October 9, 2017

Addendum 2 Chevrolet of New Bern

ADDENDUM 2

BD-1

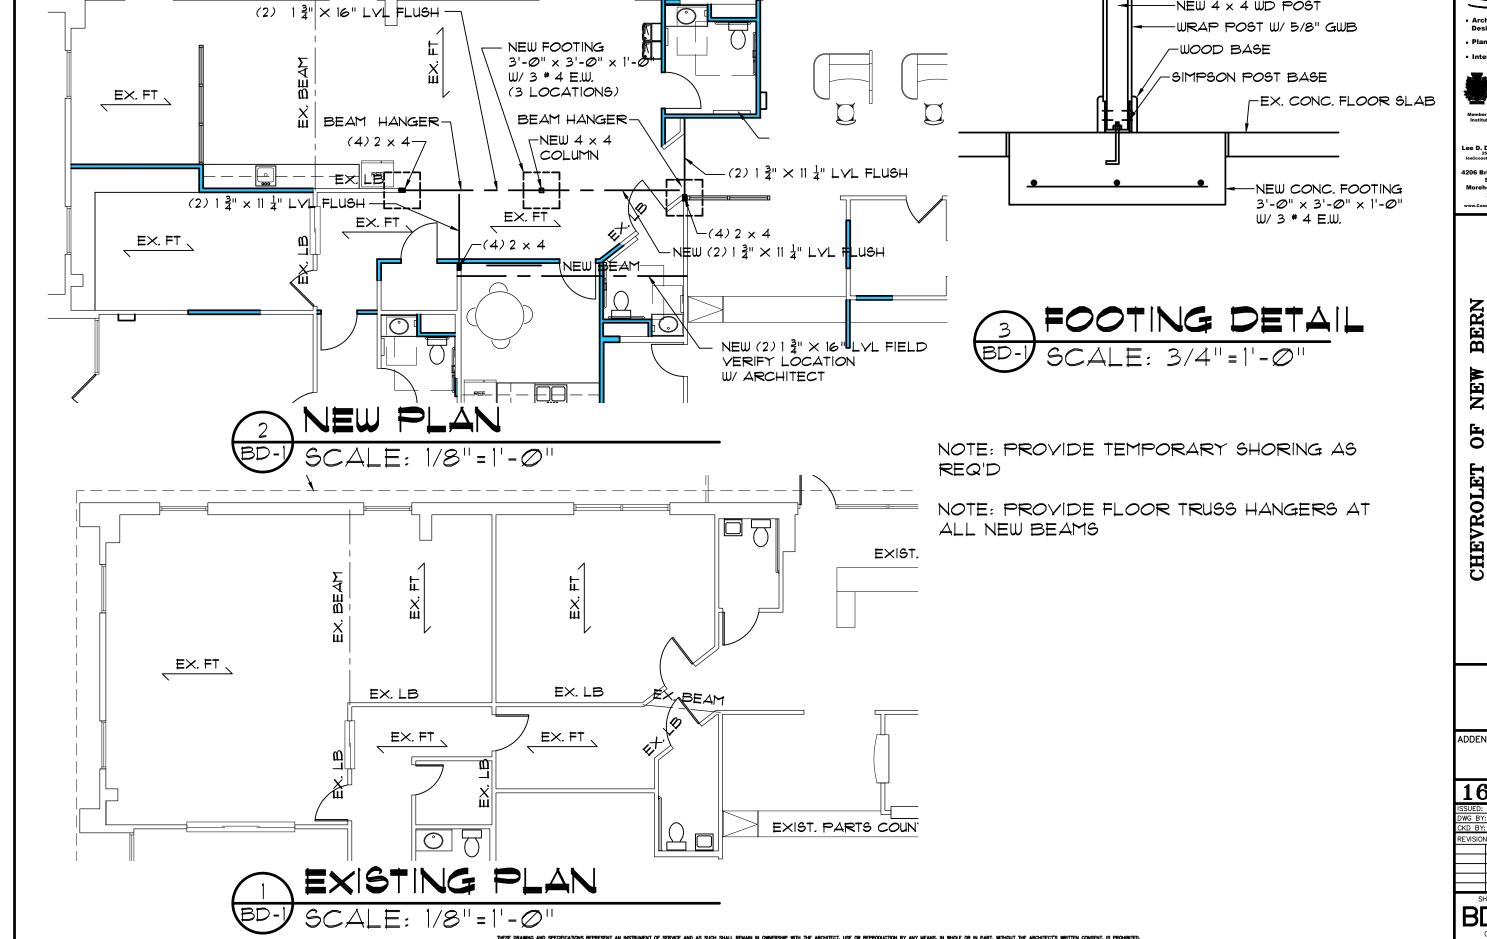
- See attached BD-1
- Clarification: The new Lincoln Volvo Service Drop-off canopy is to be a PEMB. It is understood
 that some minor modifications are necessary to fit PEMB structure requirements. All columns
 and fascia to be clad with ACM on ice and water shield on 5/8" plywood attached to framing as
 required.
